Eastern Caribbean Telecommunications Authority

**Recommendation to
National Telecommunications Regulatory Commissions
on
Cost Oriented Interconnection Rates in the ECTEL Member States**

April 2018

Exhibit 3.1: Bandwidth (uplink plus downlink) available for operators in each market and allocation to technologies.

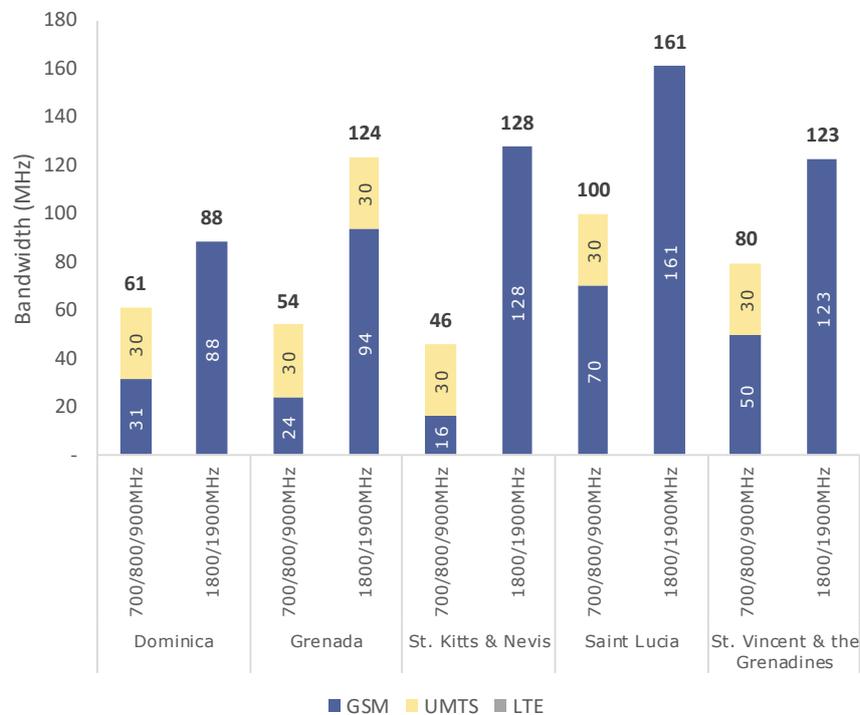
C&W asked if the exhibit represents the actual aggregate bandwidth available for allocation, or if the exhibit shows the bandwidth not yet allocated to market participants.

Exhibit 3.2: Topology of the mobile core network for Grenada. [Source: Axon Consulting]

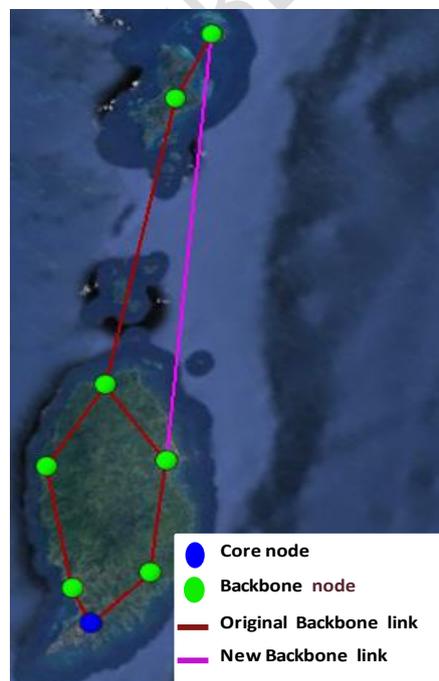
Digicel stated that “[*t*]he backbone networks shown for Grenada and St. Kitts and Nevis do not include resilient links: ring structures and resilient inter-island links would be reasonable to ensure the modelled network has a reasonable level of resilience to a single link point of failure between one of the islands. Digicel does not agree with C&W on this question, and recommends that additional microwave links will be needed to provide this resilience (as appears to have been done for the network linking St. Vincent and the Grenadines)”.

ECTEL agrees with Digicel and notes that every island would be benefited by redundancy and, therefore, it should be considered in the model. Then, ECTEL accepts Digicel’s proposal and included resilient links for Grenada and St. Kitts and Nevis, as shown below:
